APPENDIX A:

Facility Reports

City Hall - Exterior
2600 Fresno Street, Fresno

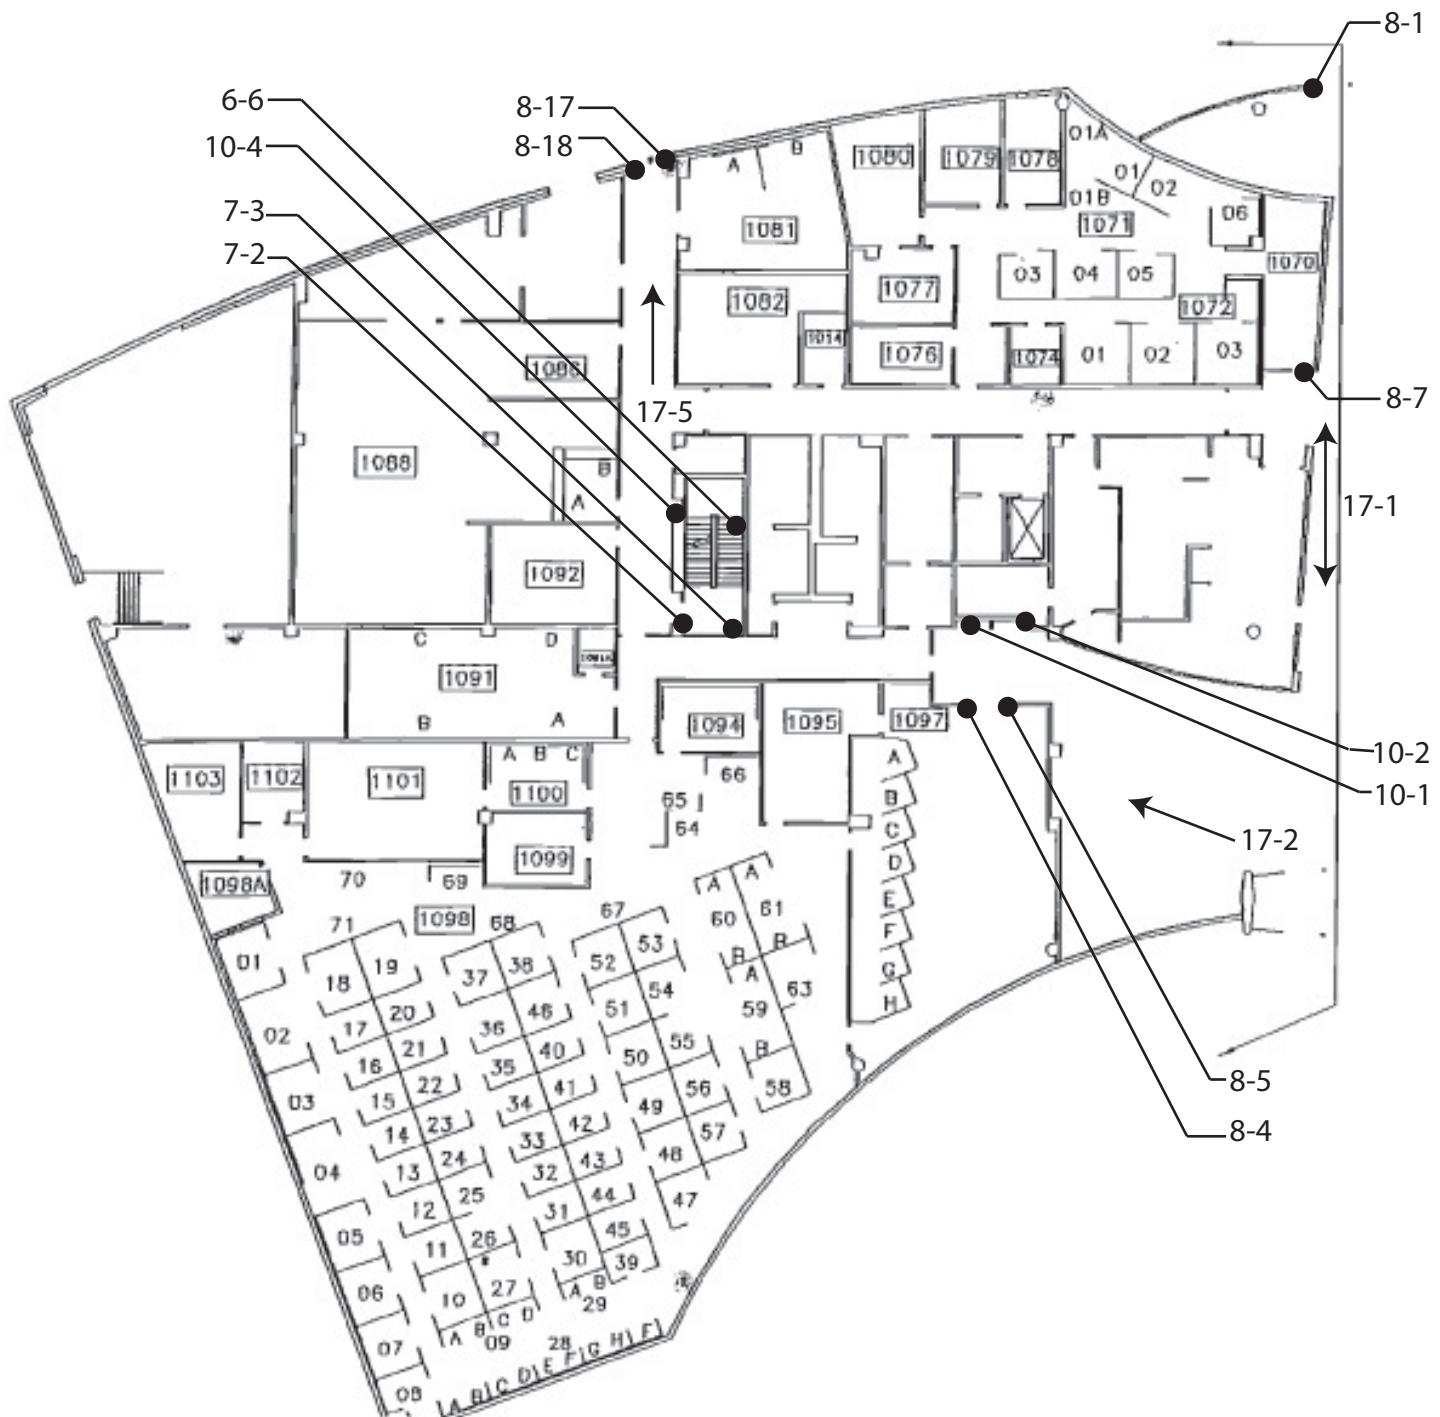
6 - 4 Stairway	Priority: 1
Install or modify handrails	\$2,000
Notes: Handrail diameter is 1-3/4" (1-1/4" to 1-1/2"). Handrail is 7-3/4" (1-1/2") to the wall.	
State: 1133B.4.2.5, 1133B.4.2.6	
Federal: 4.26.2, 4.9.4 #3	
34 - 1 Fixed Bench	Priority: 4
Provide accessible fixed bench	\$900
Notes: Back support is not provided. Armrests are not provided.	
State: -	
Federal: -	
Increase or provide maneuvering or clear floor area	\$2,500
Notes: 30" x 48" min clear floor space is not provided at either end of the bench for companion seating due to bollards.	
State: -	
Federal: -

Provide accessible fixed bench

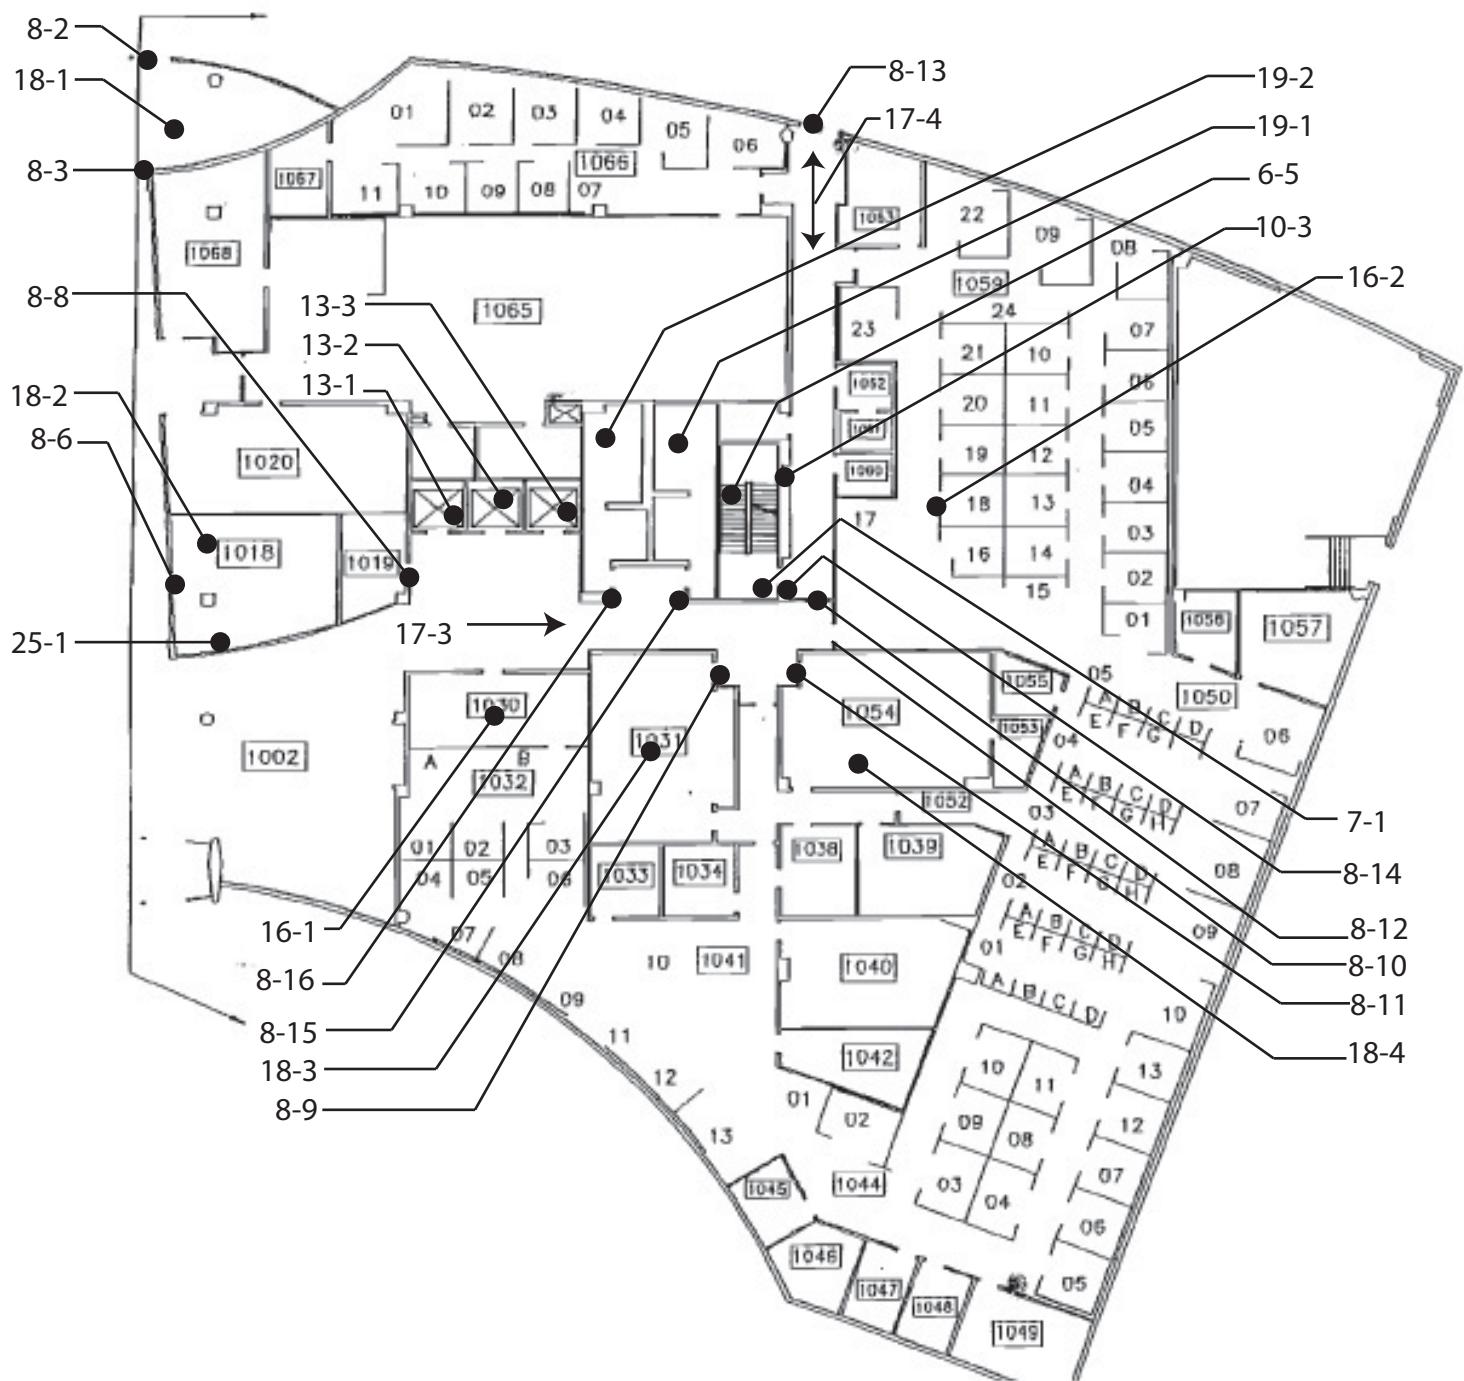
Increase or provide maneuvering or clear floor area

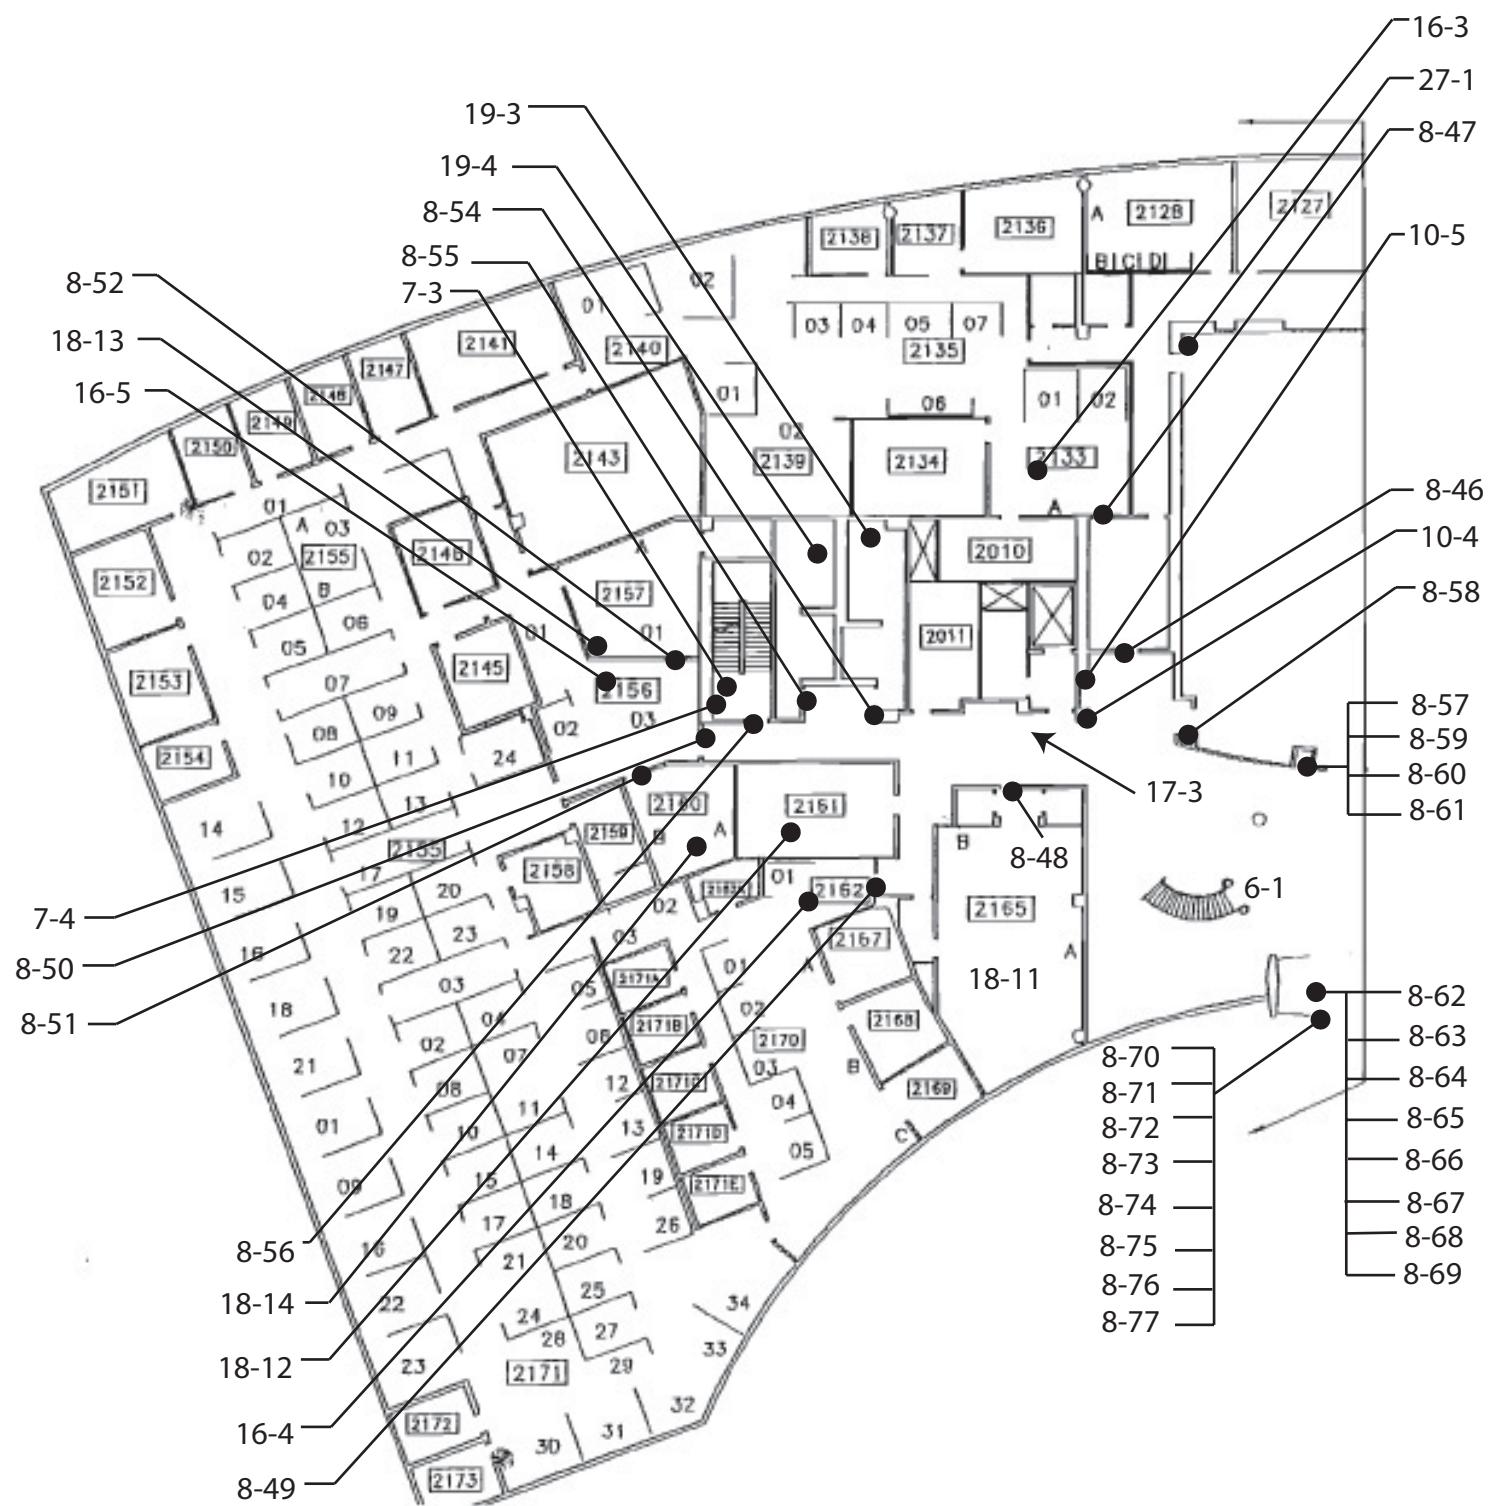
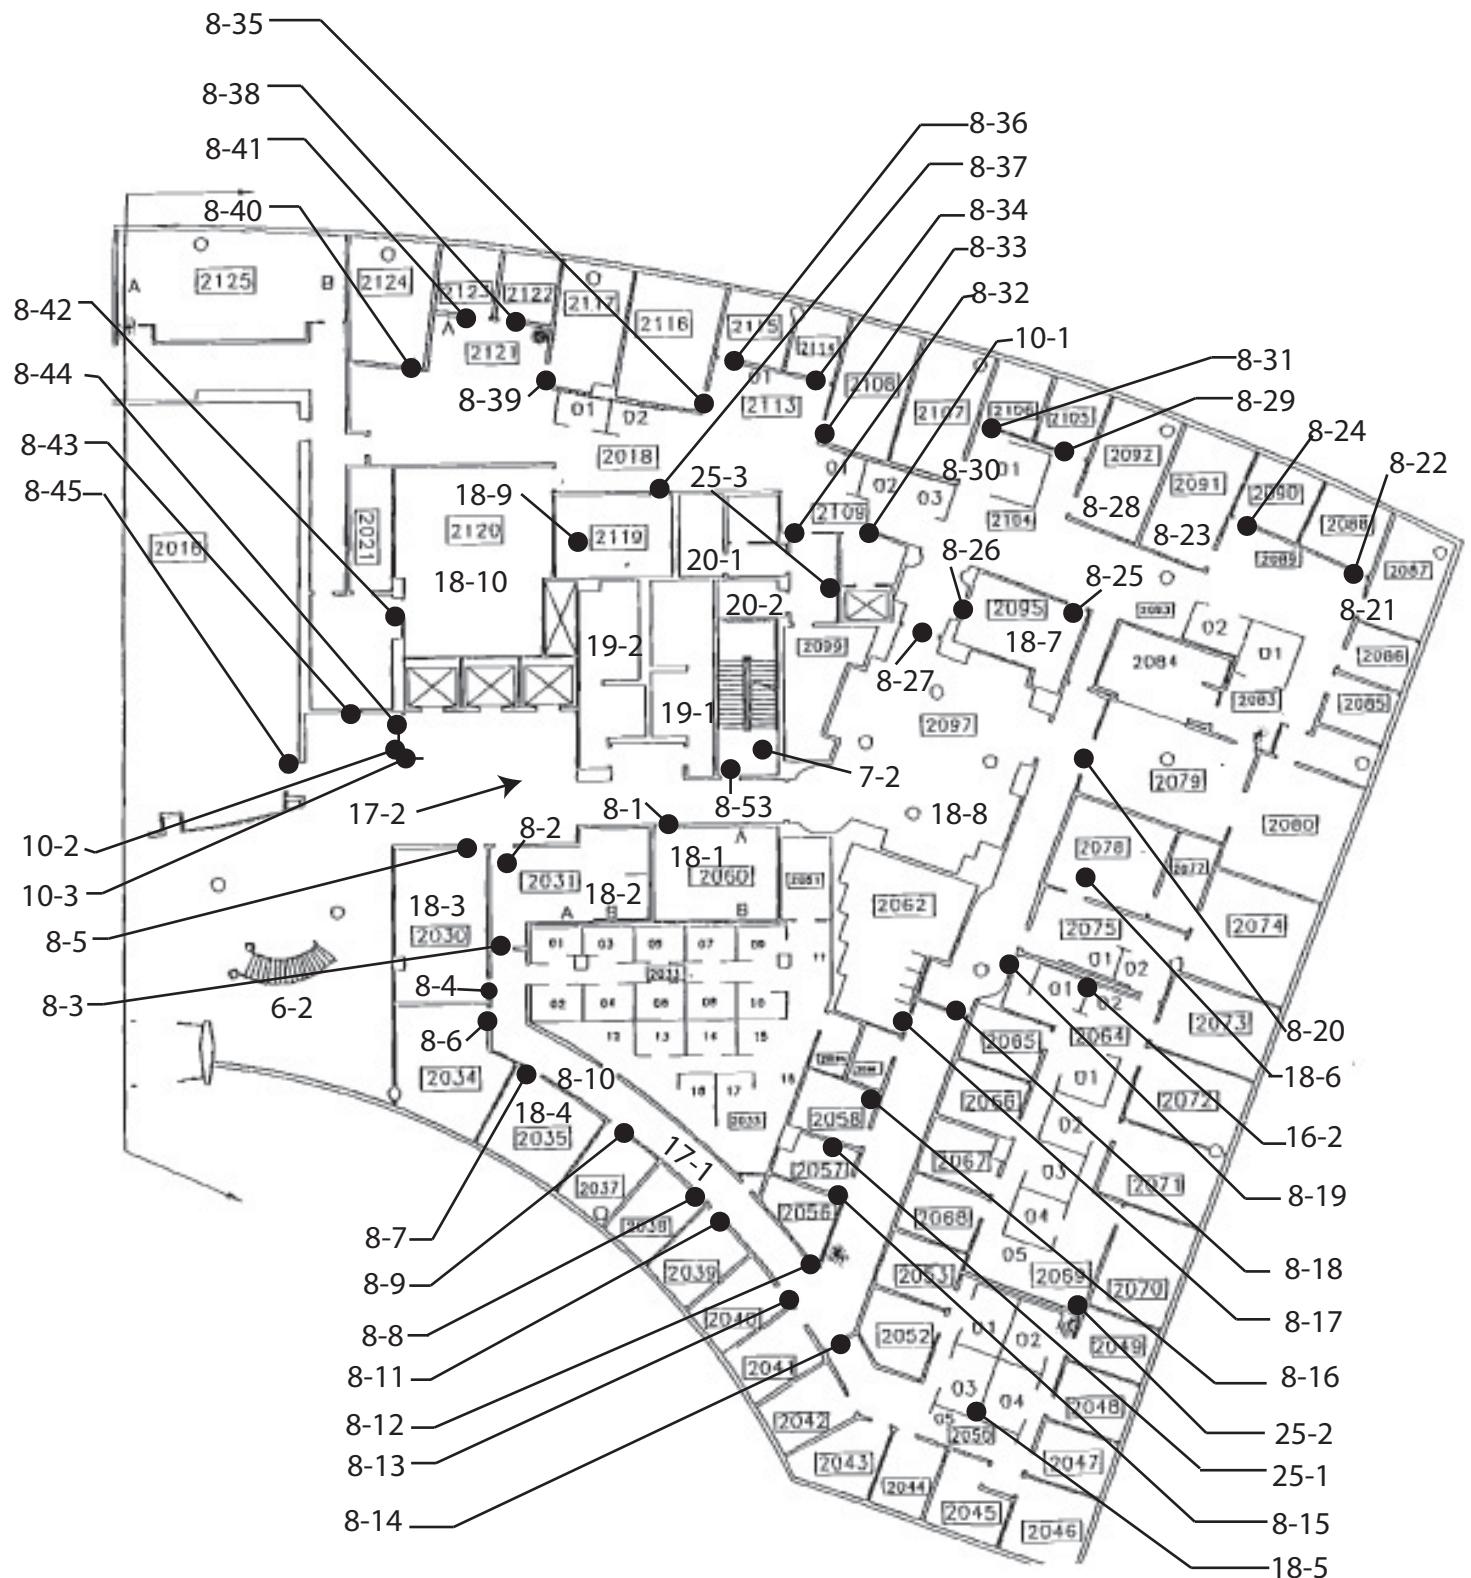
19 - 2	Multiple User Restroom	Priority:2
Modify lavatory/counter clearances		\$3,500
Notes:	Height of counter is 36" (34" max) above the finished floor. Lower lavatory.	
State:	1115B.4.3 #2	
Federal:	4.19.2	
Provide or replace stall door hardware		\$100
Notes:	Stall door is not self-closing. U-shaped handle is not provided on the back side of stall door.	
State:	1115B.3.1 #4.5	
Federal:	4.13.9	
Modify stall partitions and doors		\$800
Notes:	Door width for side-entry stall is 33-1/2" (34" min).	
State:	1115B.3.1 #4.4	
Federal:	-	
Reposition toilet flush controls		\$750
Notes:	Flush control is not located on the wide side.	
State:	1115B.4.1 #5	
Federal:	4.16.5	
Replace or reposition dispensers or mirrors		\$100
Notes:	Seat cover dispenser is 41" (40" max) above the finished floor.	
State:	1115B.8.3	
Federal:	4.23.7	
25 - 1	Kitchen	Priority:3
Provide an accessible counter		\$4,000
Notes:	Countertop is located 36" (34" max) above the finished floor. Base cabinet directly under the sink does not provide clearance for a wheelchair.

State:	1115B.4.7 #1	
Federal:	1115B.4.7 #1	
Modify lavatory/counter clearances		\$3,500
Notes:	Height of counter is 36" (34" max) above the finished floor. Sink is 7" (6-1/2" max) deep. Provide an accessible sink.	
State:	1115B.4.7 #1	
Federal:	4.24.2, 4.24.4	
Replace or reposition dispensers or mirrors		\$250
Notes:	Paper towel dispenser is 44" (40" max) above the finished floor.	
State:	1115B.9.2	
Federal:	4.23.7

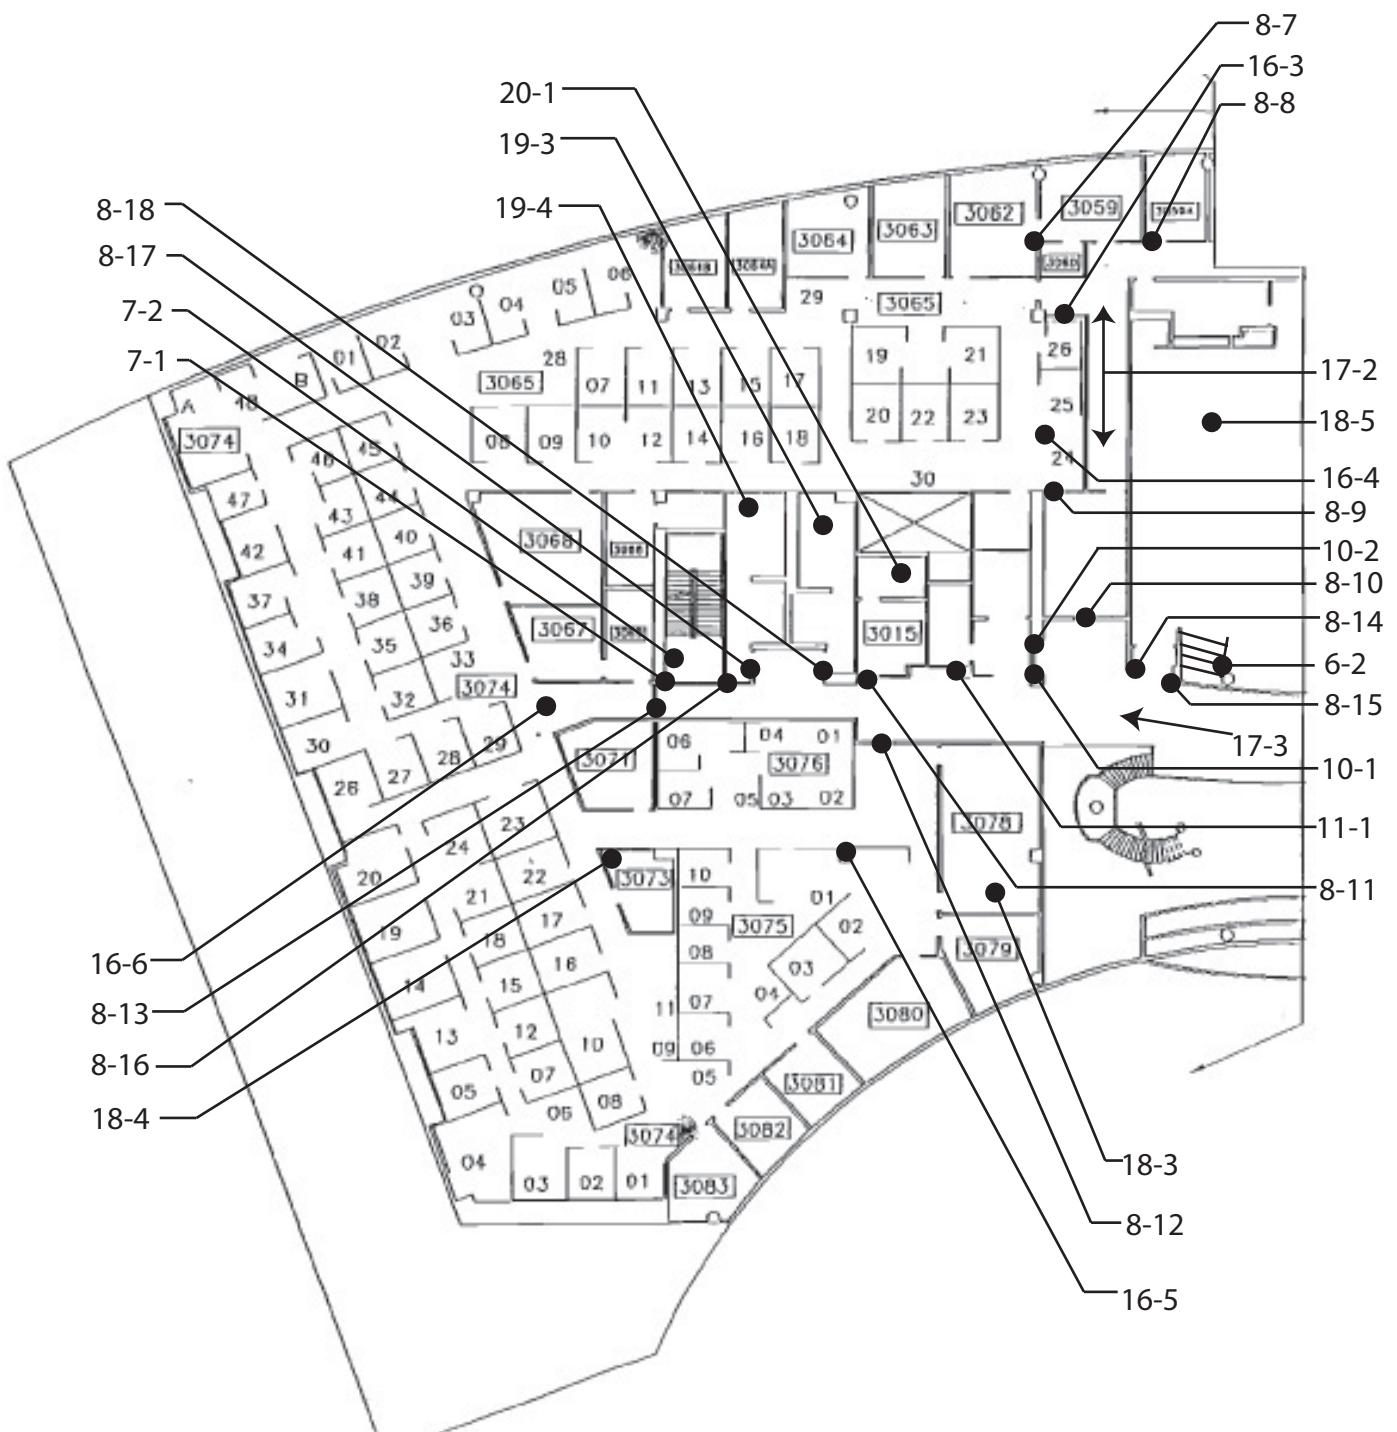
Provide accessible seating

Notes: Removable armrests are not provided on the aisle sides. Provide 1% (at least one) of all fixed seats on the aisle to have removable armrests. Indicate these seats with an ISA.
